5415 Mohican Road, Bethesda

[HPC 35/29-13A]

Date: August 22, 2013

SUBJECT: Historic Area Work Permit #643959, construction of rear addition, enclosure of front porch,
construction of new carport and other alterations

1 Front Porch Glazing Detail
1/2\"/>

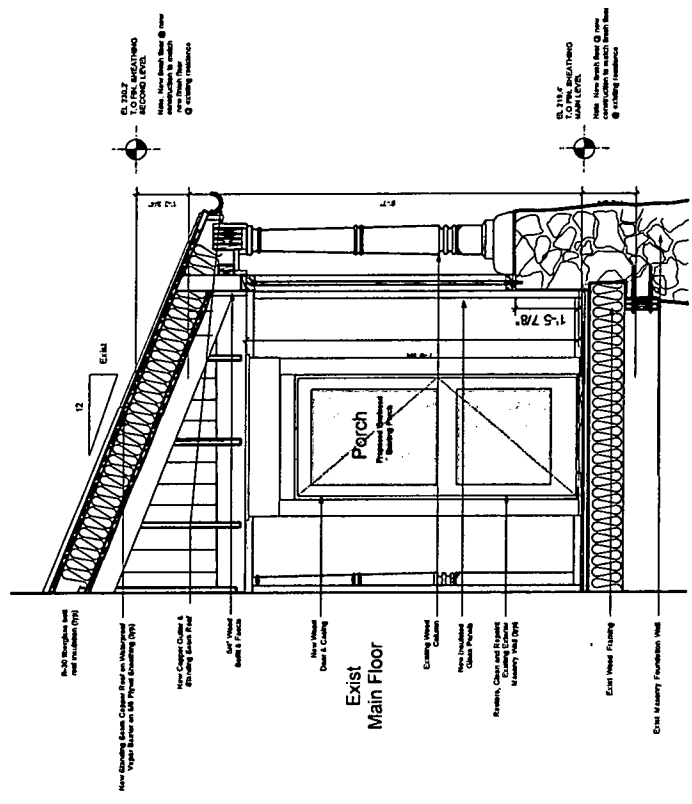
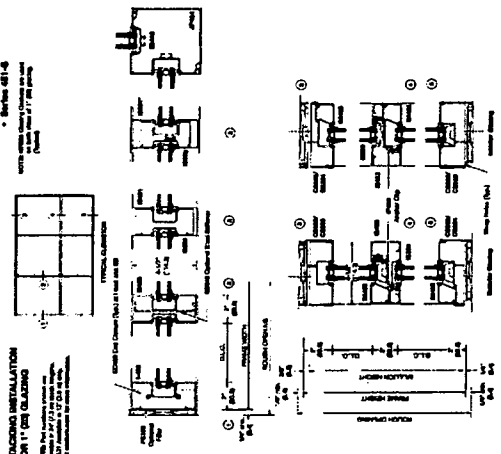
- A majority of the HPC supported enclosing the front porch with glass if the glazing was either in plane with or located behind the existing turned wooden porch columns. Additional details for how the glazing would be installed and attached to the front façade were recommended.

- Remove and replace a non-original asphalt roof with a seamed copper roof. Enclose the existing front porch by adding full view, fixed, reflective glass behind the original wooden porch columns. The existing porch columns and stone piers will be preserved. A porch glazing detail can be found on page 540-41 of the staff report packet.

2 Front Porch Glazing Detail
1/2" = 1'-0"

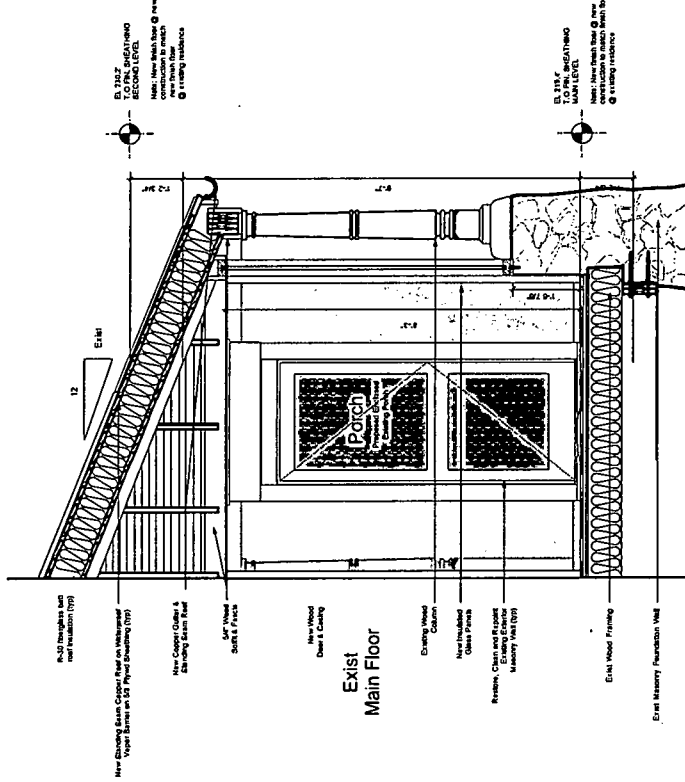
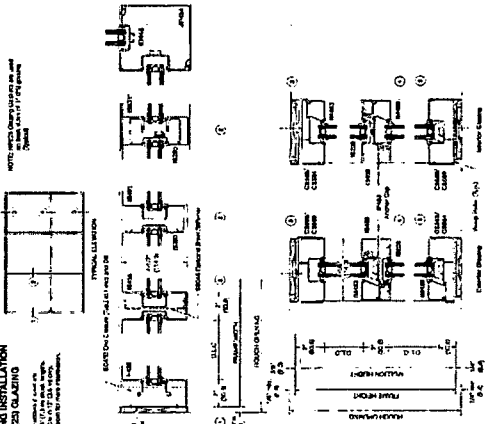
8 MR. KIRWAN: -- and that's the extent of it. The
9 detail clearly shows a much deeper soffit which is going to
10 be required to receive the exterior glaze panel. Deepening
11 that soffit will, in turn, probably cause a chain reaction
12 of having to rebuild or overlay a structure on top of that
13 existing porch roof. So the porch roof will be changed in a
14 sense. It will be, material will be added to it to achieve
15 that soffit, is that, was that identified at all or was the
16 understanding that there was no change to the --

3 MR. RODRIGUEZ: Yes. Can you talk a little more
4 about this enclosure of the porch because I notice what
5 Commissioner Kirwan discussed already, that to do what
6 you're proposing, you realize that you are going to have to
7 change the structure of the roof and that changes the line
8 on how the porch relates to the house which is a very
9 critical detail when you see the columns on the edge of the
10 house, how they work, the columns, the gutter, this little
11 soffit between the columns and the fascia that, all those
12 elements are integrated and they are part of the whole
13 detail that goes from the column to the lot. So can you
14 explain exactly what you're trying to do because I really
15 have concerns about bringing pieces of glass that not only
16 enclose the porch outwards of this perimeter at this moment,
17 but also that they are, seem to be hanging in the air with
18 no connection to any -- and it's a little strange to me and

10 MR. RODRIGUEZ: Exactly. So there is a whole
11 detail of the glass crossing the wall, where it goes, how to
12 support it, that's what I'm trying to understand. I
13 understand what you did in the previous house and I
14 understand the idea, but I'm just trying to figure out why
15 it has to be so upwards and if there was any, I don't know,
16 desire to do something else or what it was driving at. I
17 understand the technicality that I don't know if you can see
18 all the technical problems that I can foresee when you need
19 to turn the glass 90 degrees to close the side of the porch.

8 MR. KIRWAN: You're showing the detail about a
9 foot or more of overhang and that's not consistent with what
10 you're describing.

12 MR. KIRWAN: Because to replace the glass as where
13 you're putting it is going to require, I think, the soffit
14 as you're showing in the detail or something close to it, so
15 I think that's something that needs to be looked at, but I
16 would probably listen to more comments about the glazing of
17 that porch before we have to deal with that issue. Any
18 other questions? Yes.

Staff finds the revised proposal to locate the fixed glass behind the existing turned wooden columns responds directly to the HPC's feedback at the 2nd preliminary consultation. The applicant has provided an updated drawing and written narrative to describe the installation process.

11 MR. MCNAIR: Okay. I can revise the detail.
